The Historic Zoning Commission recently received funding from the Tennessee Historical Commission for a design guideline consolidation project. The project will take place between January 2019 and September 30, 2019.

The Design Guidelines Consolidation Project includes two main components. One is to consolidate all the neighborhood conservation design guidelines into one basic set of design guidelines, with individual chapters for each district. All of the neighborhood conservation design guidelines are already very similar but the consolidation will provide an opportunity to reorganize and add clarifying language. The goal is to provide clarity to users of the document. The second component is to create new design guidelines and a plans book for outbuildings, to provide more flexibility in terms of size and design and clearer guidance.

# SUMMARY REVIEW OF CHANGES

#### **ISSUE 3: MATERIALS**

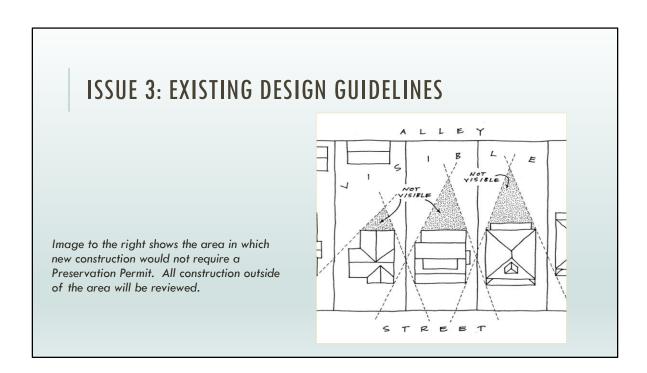
Current guidelines call for "visual compatibility" with historic materials.

Provide examples of types of materials that would be appropriate and those that would not.

The design guidelines allow for the addition of italicized information without a formal public process in order to provide further guidance to the existing design guidelines. We propose leaving these materials as italicized so the section can easily be revised as new materials become available.

#### RECOMMENDATION 7

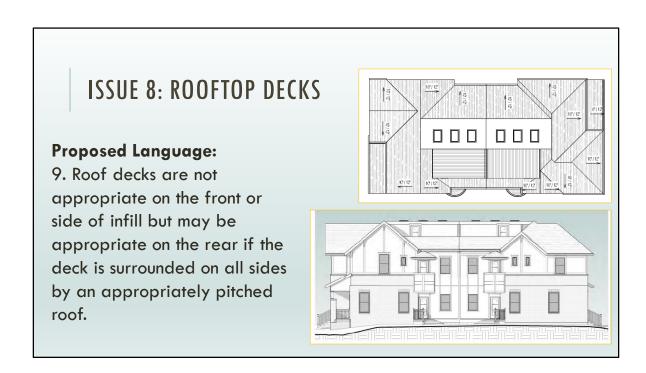
Context is an important consideration, possibly the most important consideration, of the Commissioner when looking at infill construction. In the past, the Commission has considered any extant building in a historic overlay as providing context; however, some districts, especially some of the larger ones, have different contexts within different pockets of the neighborhood. The result was the occasional building that stands out from its context, and not in a good way.

Therefore, in more recent years, the Commission has only considered the "immediate context" when considering the appropriate massing and scale for infill.

The height of the foundation wall, porch roof(s), eaves and ridges and the width of a new building shall be compatible with surrounding historic buildings on the block face. Where there are block faces with little historic context, the adjoining blocks may be used.

We recommend that clearer guidance on what is "immediate context" would be useful but want to be careful that it is not defined two narrowly to be able to address multiple situations.
